Access Compliance Report

Public Rights-of-Way

(Curb Ramps)

Intersection ID: 44271	Main Street: BRITTNI_DAYLE_DR	Cross Street: TRAVIS_FLOYD_LN	Location: NW
ADA ID: 8CE15FC94A13	Ramp Type: PerpDiag	Initial Pass/Fail: Fail	Overall Compliance: No
Severity Score: 33.75			
Codes/Mitigation Info/Possible Solution		Field Measurements/Component Compliance

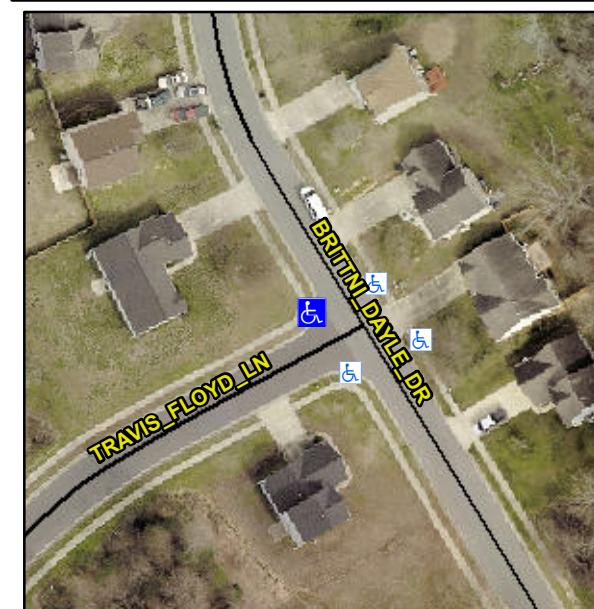
Not Found, R304.5.1, R304.5.3

Compliance	Description	Data	Compliance	Description	Data
N/A	Ramp Length (in)	47.0	Yes	Ramp Slope (%)	5.0
No	Ramp Width (in)	41.5	No	Ramp XSlope (%)	9.4
N/A	Flare Type LT	N/A	N/A	Flare Type RT	N/A
N/A	Flare Slope LT (%)	N/A	N/A	Flare Slope RT (%)	N/A
N/A	Flare Traversable LT?	N/A	N/A	Flare Traversable RT?	N/A
N/A	Landing Length (in)	N/A	N/A	DWS Provided?	N/A
N/A	Landing Width (in)	N/A	N/A	DWS Contrast?	N/A
N/A	Landing Slope (%)	N/A	N/A	DWS Length (in)	N/A
N/A	Landing X Slope (%)	N/A	N/A	DWS Full Width?	N/A
N/A	Landing Curb? (Y/N)	N/A	N/A	DWS Offset (in)	N/A
N/A	Shared Landing?	N/A			
N/A	Gutter Ponding?	N/A	N/A	Gutter Slope (%)	N/A
N/A	Gutter Lip Ht (in)	N/A	N/A	Gutter X Slope (%)	N/A
N/A	Painted X Walk1?	No	N/A	Painted X Walk2?	No
	X Walk 1 Direction	To S		X Walk 2 Direction	To E
N/A	X Walk 1 Width (in)	N/A	N/A	X Walk 2 Width (in)	N/A
	X Walk 1 Slope (%)	2.6		X Walk 2 Slope (%)	7.2
	X Walk 1 X Slope (%)	6.4		X Walk 2 X Slope (%)	4.7

Remove & Replace Curb Ramp With Two New Directional Ramps or Equivalent.
